**Q2 :** The proponent must specify the course of the curve located near km 4. It must specify whether rivers or wetlands will be impacted.

**Figure 3: Course of the Curve and Location of the Impacted Stream**

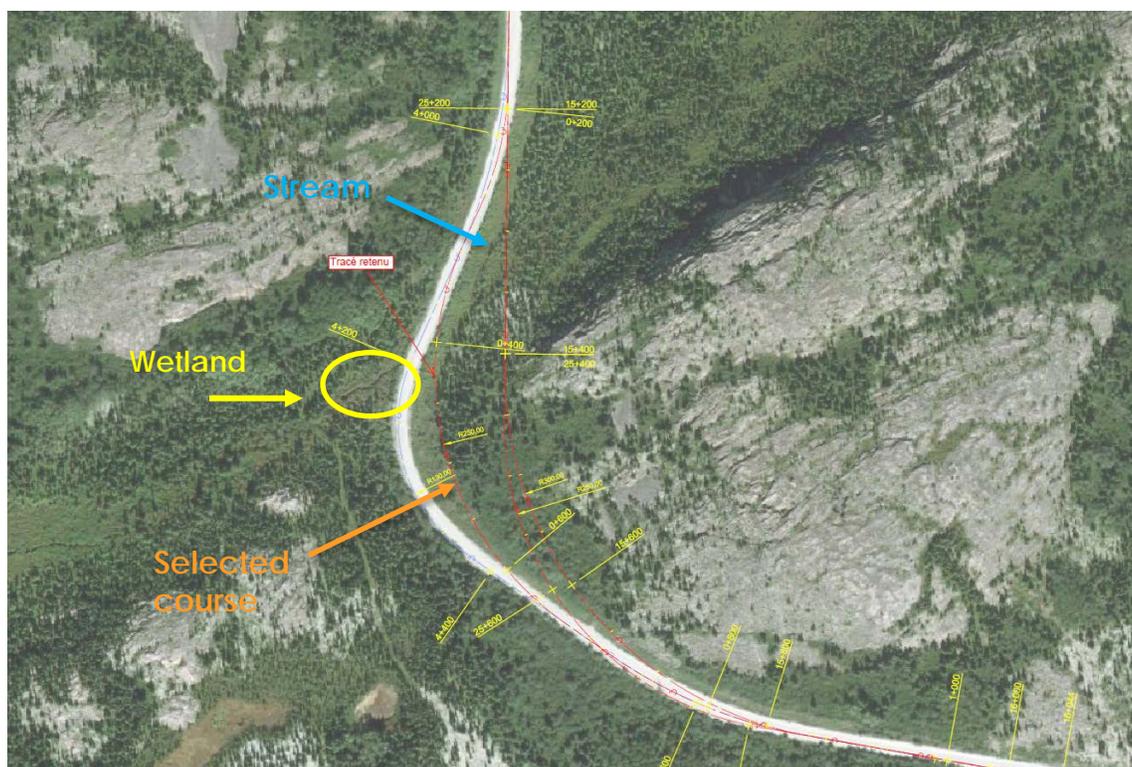
**Q3 :** The proponent must indicate whether there will be loss of fish habitat for this project. If this is the case, the proponent must implement a fish habitat compensation program.

**R2 :** Figure 3 illustrates the selected course of the curve for road construction and the stream located within the work area the project. The stream in question is labelled "Stream" in blue on Figure 3.

An alder swamp, is present along the edge of a watercourse, outside the work zone labelled "Wetland" in yellow on Figure 3. No impact is expected on this wetland.

**R3 :** One species of fish, the five-spine stickleback (*Culaea inconstans*), was captured during field surveys carried out October 20, and 21, 2017. Fish capture took place in the watercourse identified "Stream" in blue on Figure 3.

This watercourse will have to be diverted and restored over a length of 250 m as part of the road work to modify the curve. No habitat loss is expected as fish habitat will be restored at project completion.
